**Strategic Planning for Future Power Generation
Pinjar Power Station Expansion
Kwinana/East Rockingham Power Station
Kemerton Power Station
New Bunbury Power Station
Collie Power Station Expansion**

Western Power Corporation

**Report and recommendations
of the Environmental Protection Authority
under section 16(e) of the Environmental Protection Act**

**Environmental Protection Authority
Perth, Western Australia
Bulletin 1067
September 2002**

FIGURE A-3

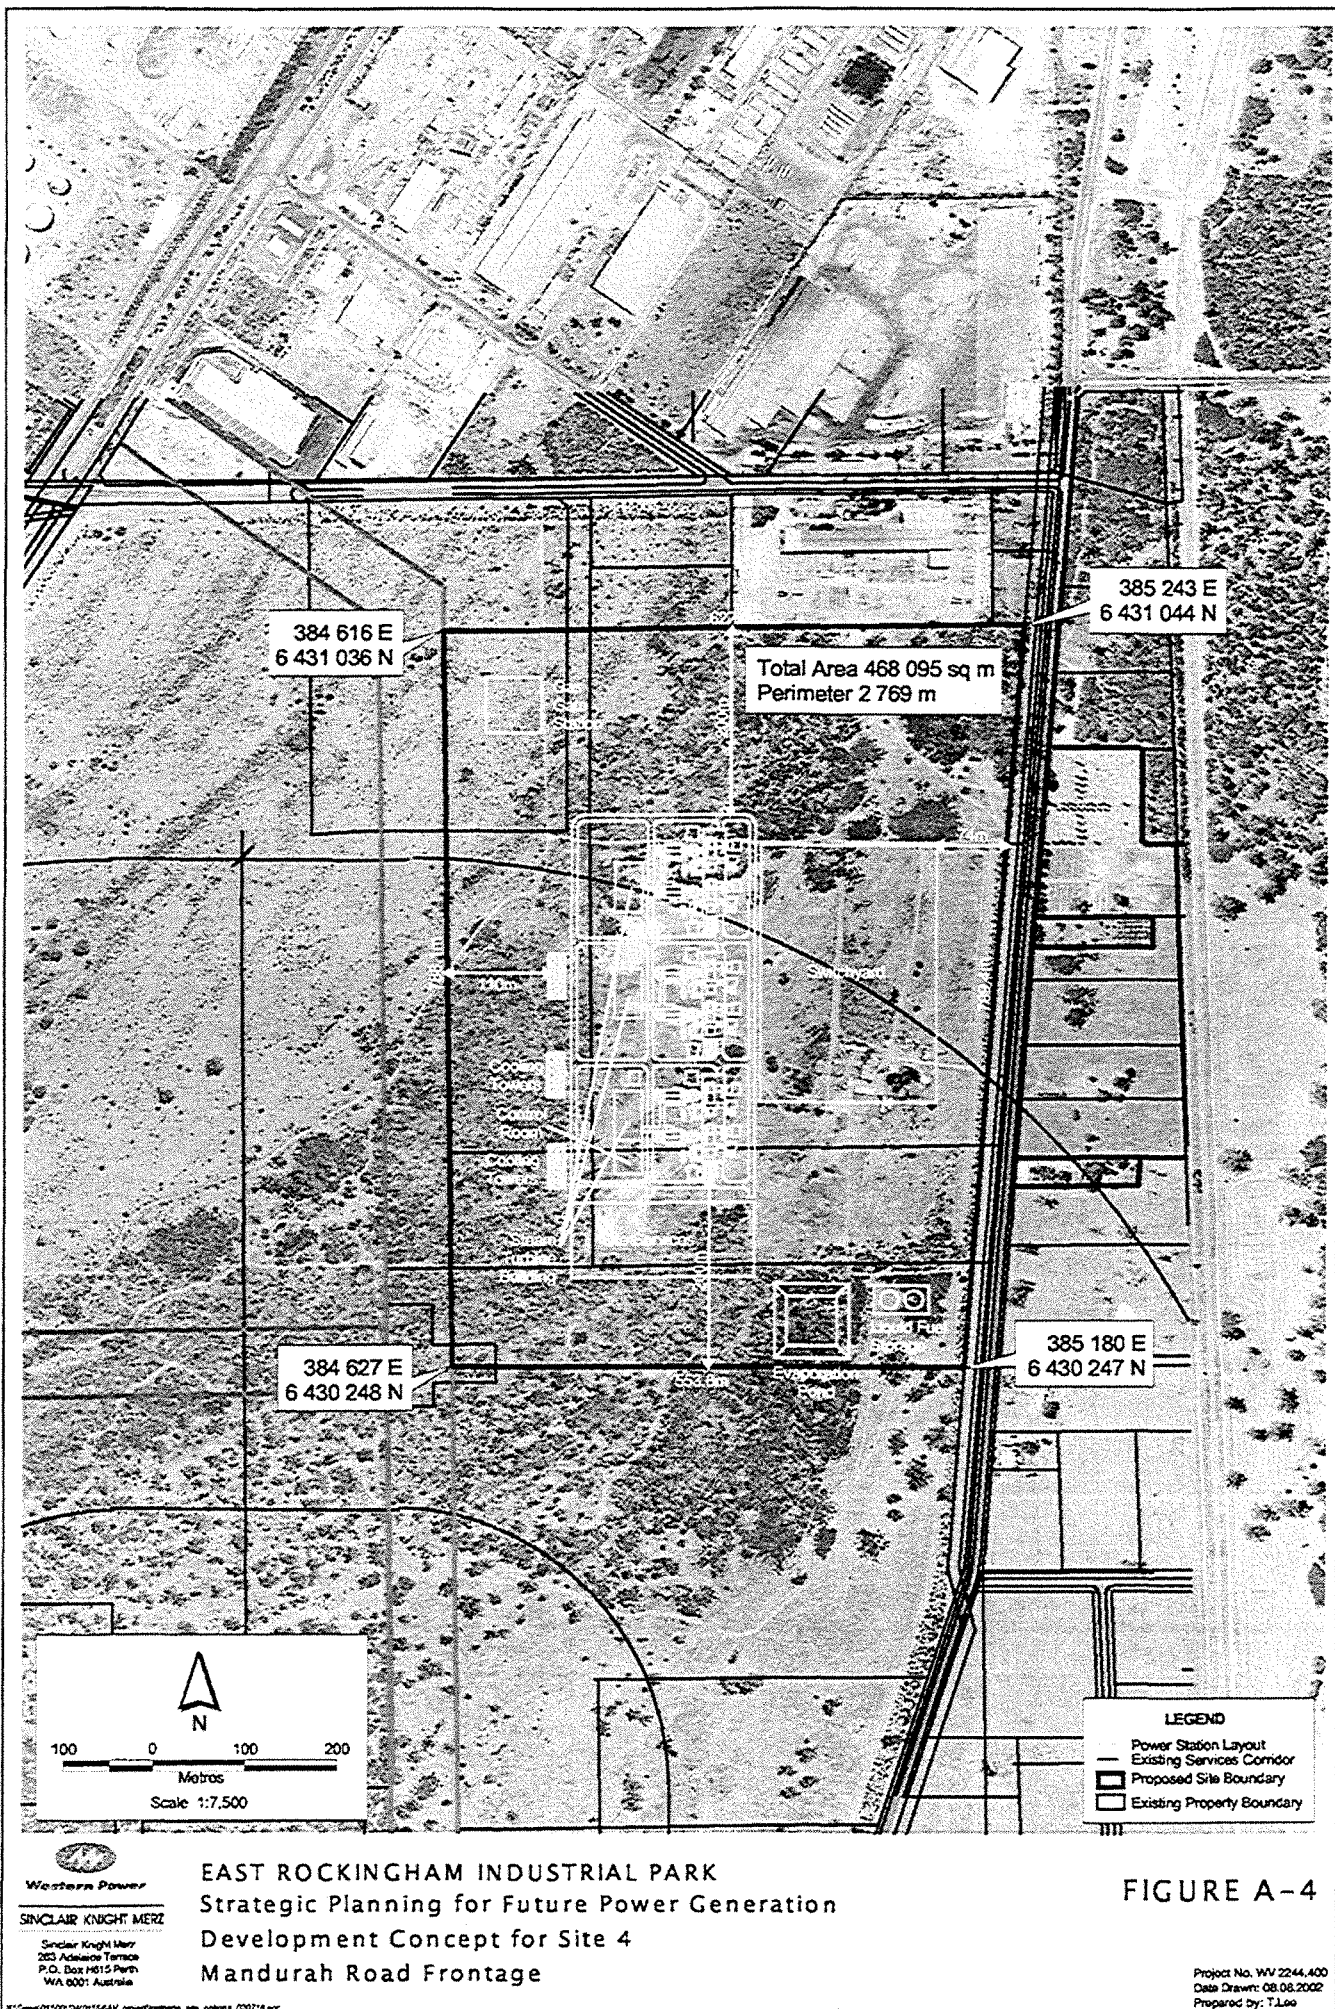
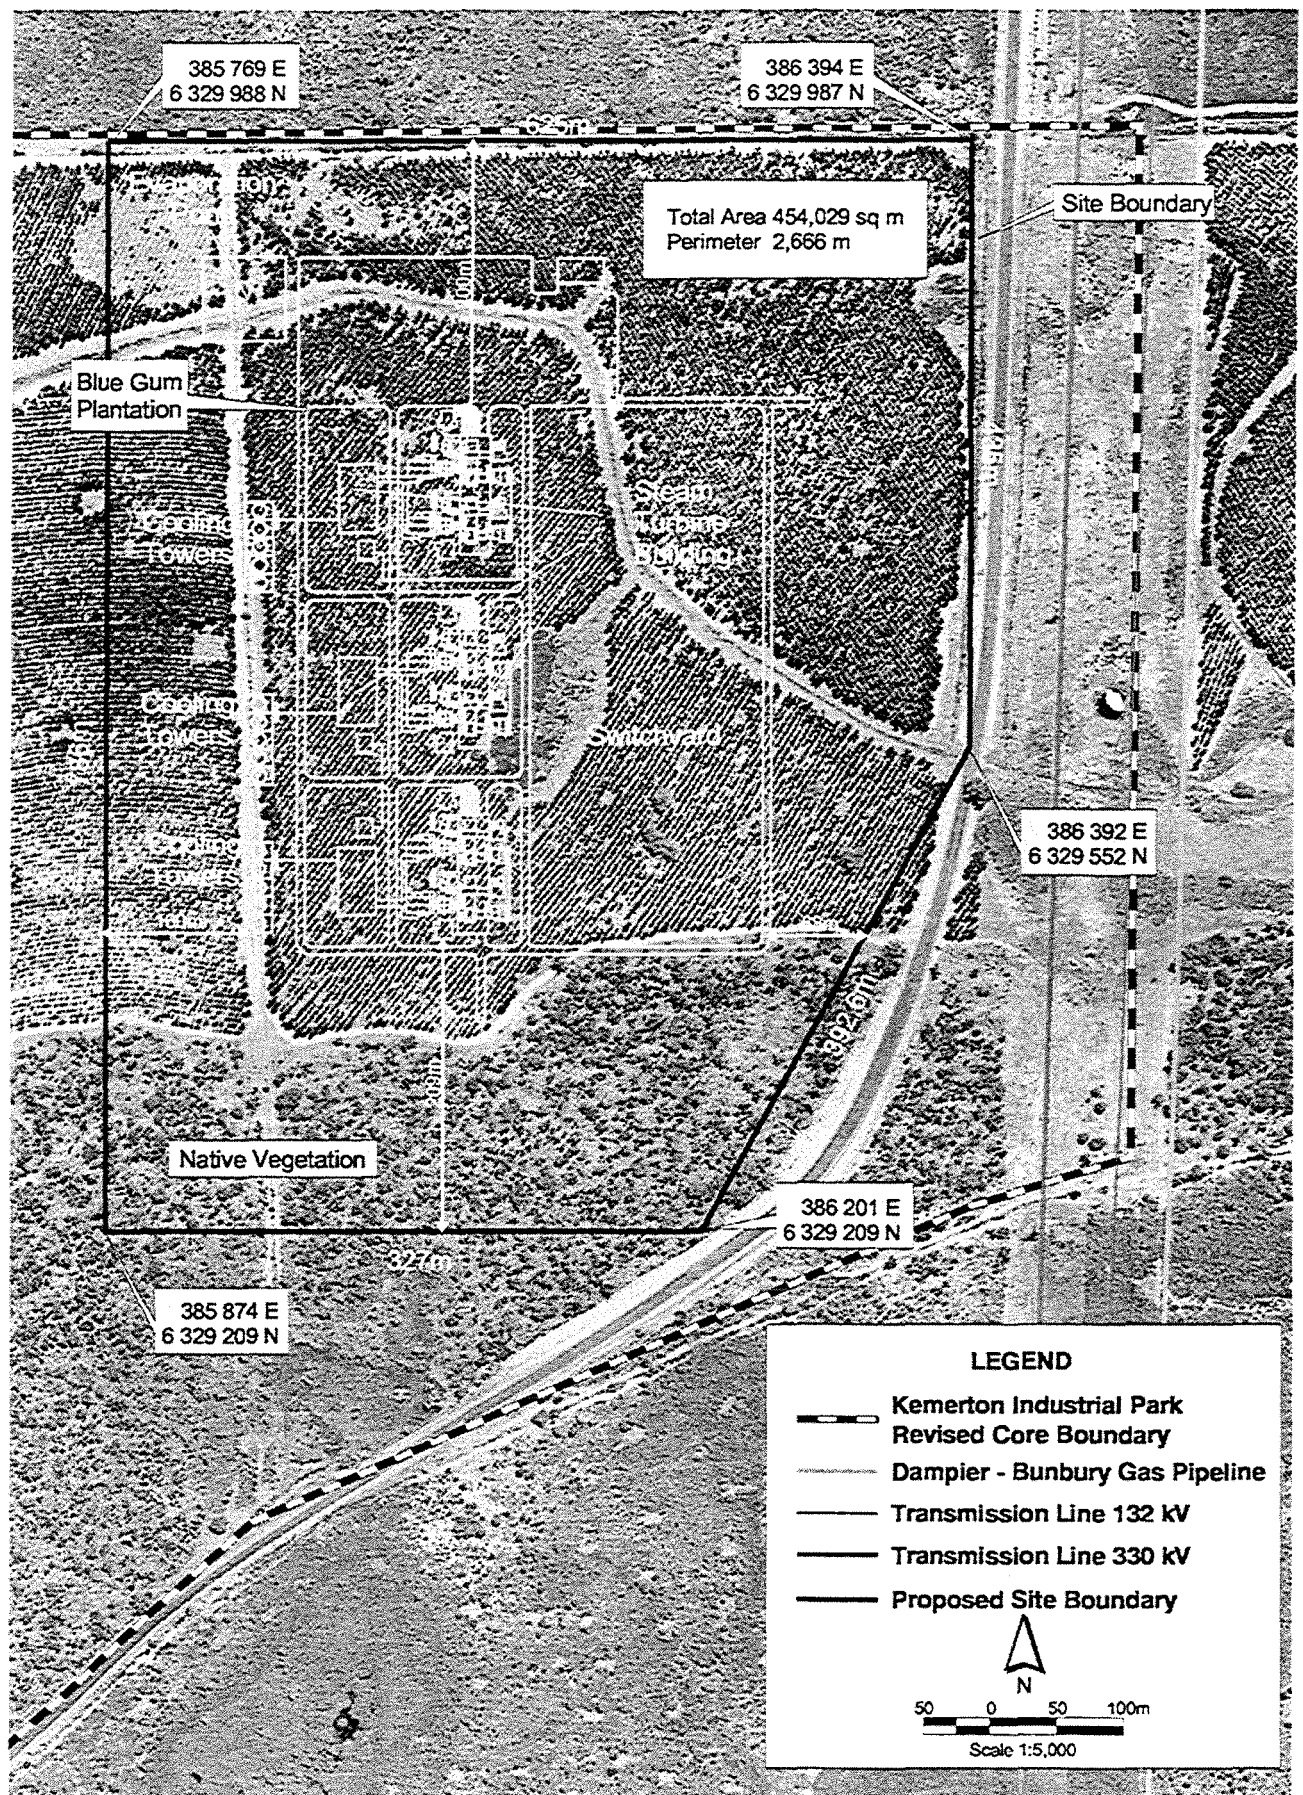
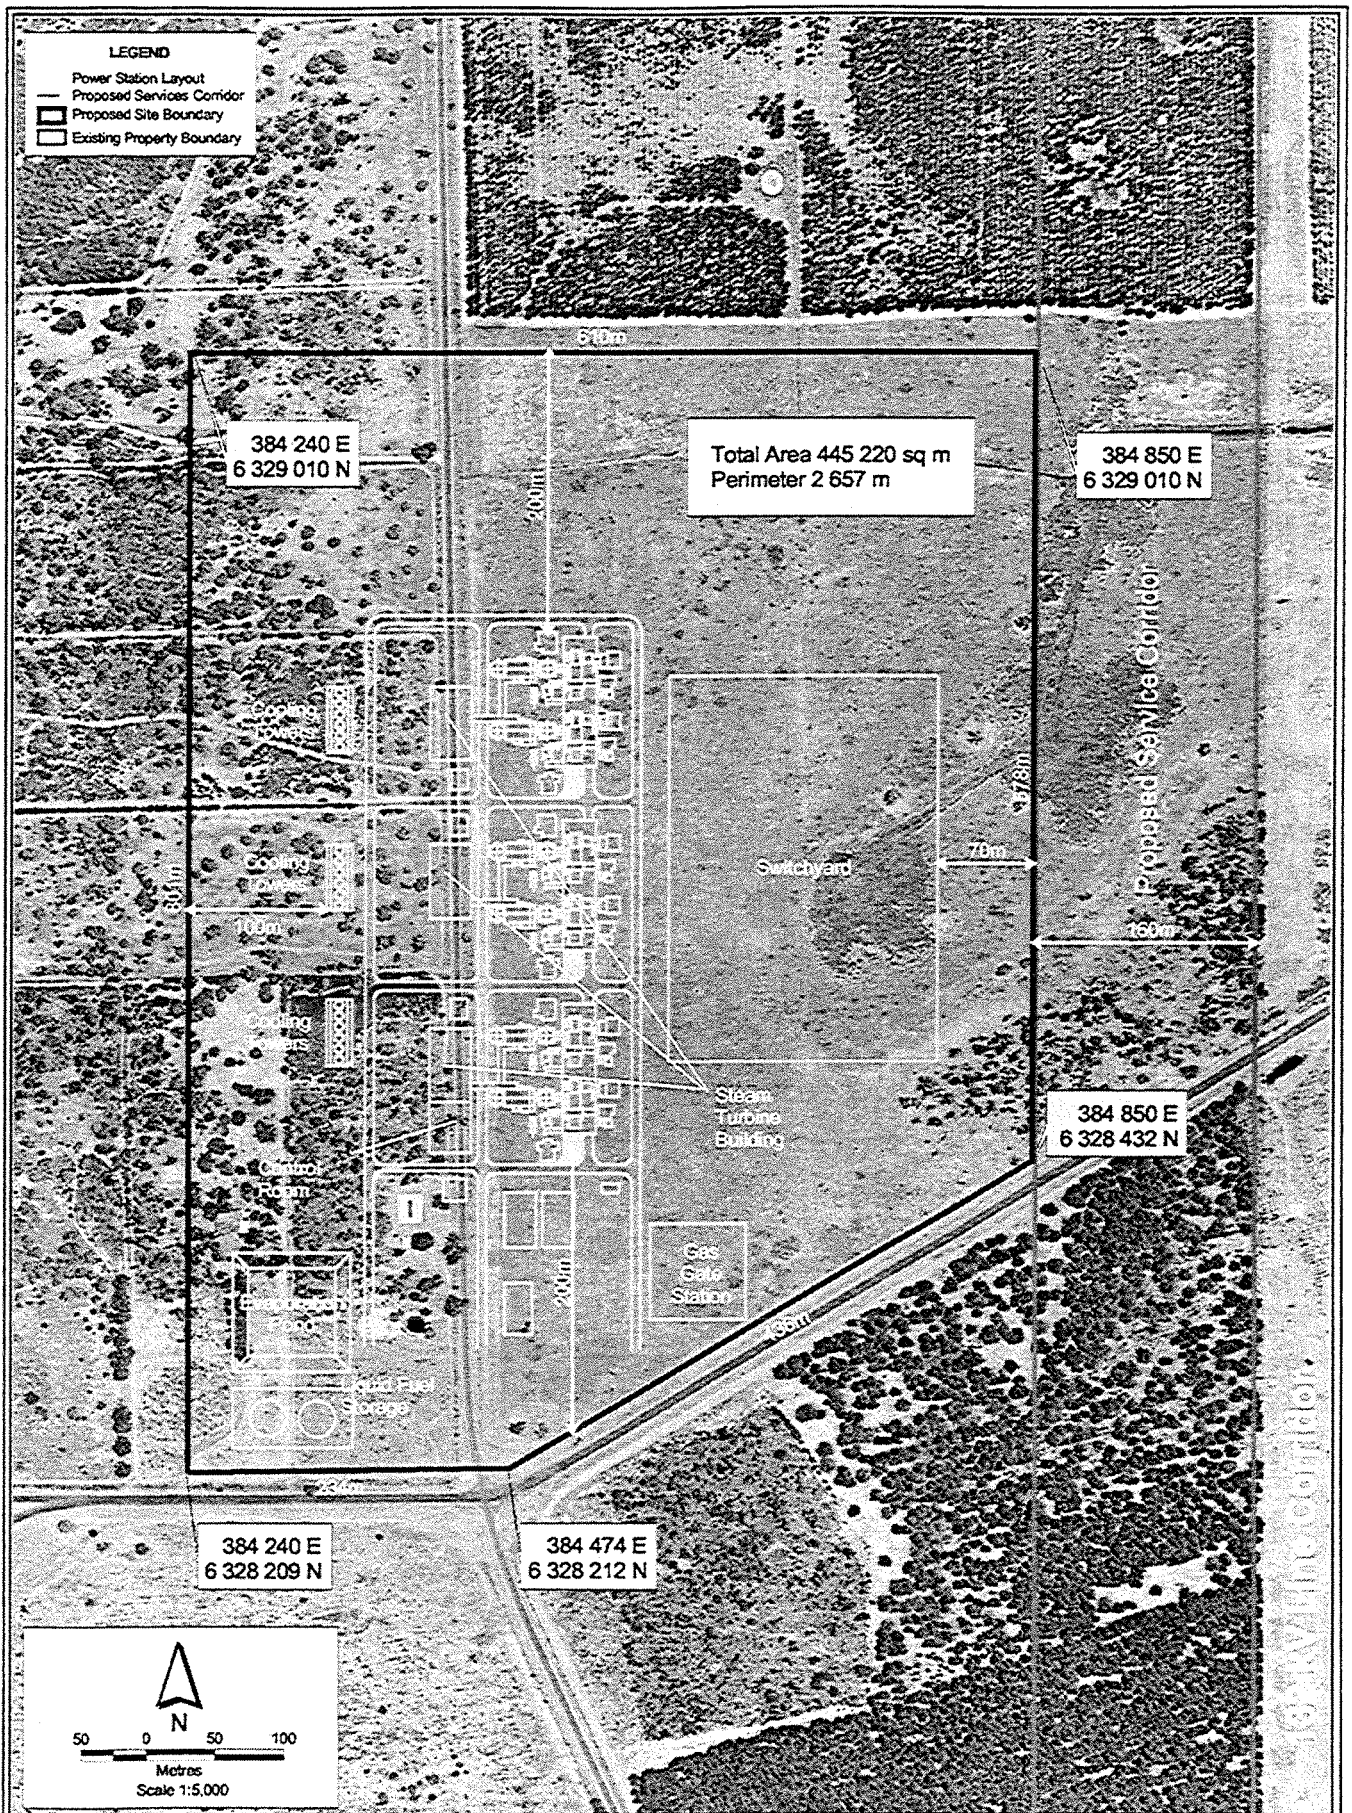
A submission pointed out that a portion of a conservation category wetland is within the site. In response to this the site layout and lease boundary have been modified to maintain a minimum of 200m separation to the nearest wetland.

The site layout for the preferred site at Kemerton has been further refined as a result of public submissions during the public review period. The new layout is shown in **Figure A-5 of Appendix A**. In this revised layout, the plant has been placed further to the north over the blue gum plantation to ensure that disturbance to the remnant vegetation in the southern portion of the preferred site is minimised. This revised layout also provides a distance of approximately 200m from the conservation category wetland in this portion of vegetation (refer to **Issue 33, Section 3.2.3.2**).

Figure 5-1 of the Kemerton SER presented a preliminary concept plan for the preferred site with indicative lease boundaries, which did include a portion of conservation category wetland in the southern most section of the site. However, in response to submissions through the public review process and ongoing liaison with LandCorp, the site layout and lease boundary have been modified. The revised power station layout (**Figure A-5**) would maintain a minimum of 200m separation to the nearest wetland such that disturbance to wetland vegetation is avoided.

The revised Kemerton power station development concept (**Figure A-5**) is separated from the conservation category wetland by a distance of approximately 200m and from the Environmental Protection Policy (EPP) wetland south of Treasure Road by a distance of approximately 300m.
